**Subject:** 55 Vastern Rd, Reading (200188) - microclimate review

**Independent Peer Review of Technical Addenda dated 2020-06-16 and 2020-07-09 (both RWDI Ref# 1901994) relating to Planning Application 200188 at 53-55 Vasten Road, Reading, RG1 8BU**

### PEDESTRIAN LEVEL WIND MICROCLIMATE ASSESSMENT

RWDI #1901994

**Figure 4: Configuration 1 - Existing Site with the Existing Surrounding Buildings - Windiest Season**

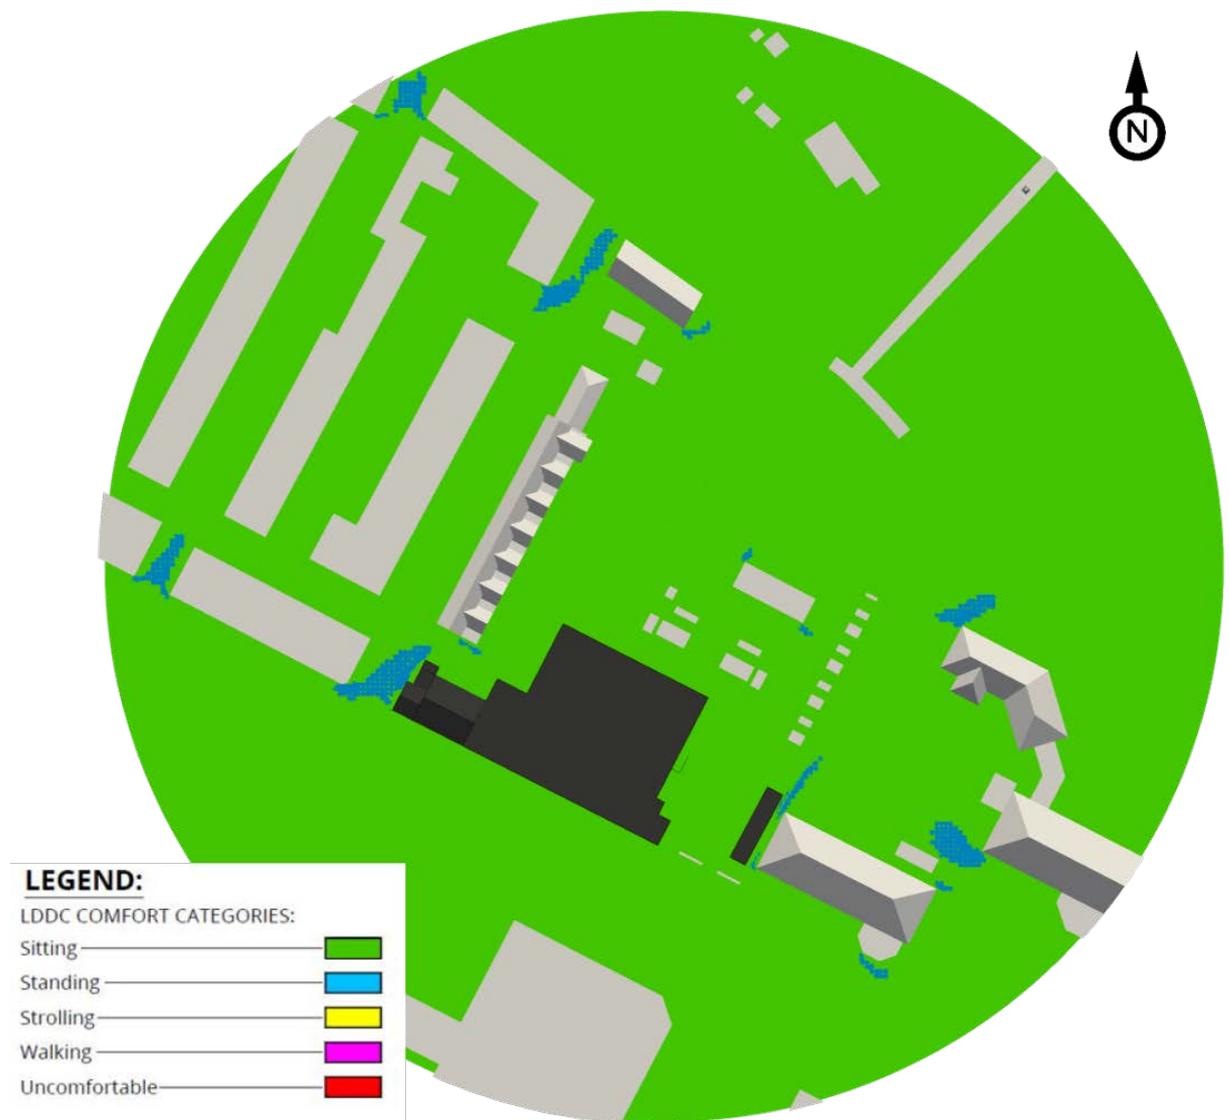
<p>than in the baseline scenario (Figure 4) These conditions would be suitable for a pedestrian thoroughfare. Further to the above, the assessment has been undertaken devoid of landscaping. As such, the inclusion of existing landscaping west of the entrance to Sovereign House would be expected to provide further shelter to the existing entrance and eliminate walking use conditions in a maintenance space west of the entrance in the context of cumulative schemes.</p>	<p>The RWDI assessment did not include landscaping. It is suggested that the inclusion of additional landscaping to the west of Sovereign House would be expected to provide shelter. However, the area to the west is not part of the planning application.</p> <p>Action required: evidence based mitigation measures must be provided to demonstrate that these unacceptably windy conditions in the surrounding existing public realm can be ameliorated.</p>
